From: Scala, Mary Joy
Sent: Monday, February 27, 2017 10:22 AM
To: 'Jeff Bushman'
Subject: BAR Action - 118 E Main Street - February 22, 2017

RE: Certificate of Appropriateness Application
BAR 17-02-02
118 East Main Street
Tax Parcel 280025000
West Cole Properties, owner/ Jeff Bushman, applicant
Replace Windows (2nd and 3rd Stories) and Storefront Renovation

**CITY OF CHARLOTTESVILLE
BOARD OF ARCHITECTURAL REVIEW
STAFF REPORT
February 22, 2017**

BAR 17-02-02

PROPOSED ELEVATION

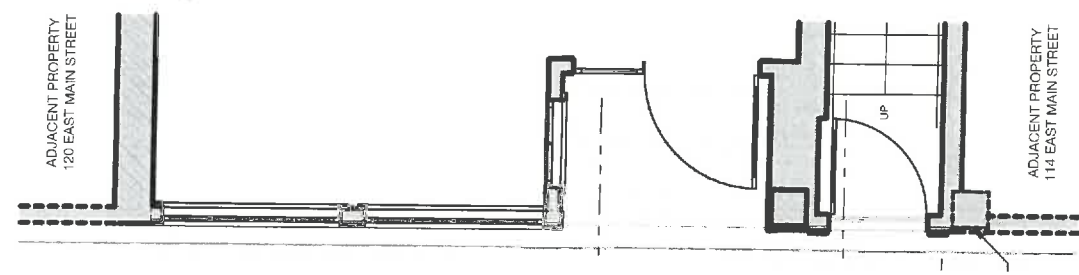
The BAR offered comments on the storefront concepts. They liked downplaying the third door; liked the dark metal façade better than Corten; and liked creating an alcove.
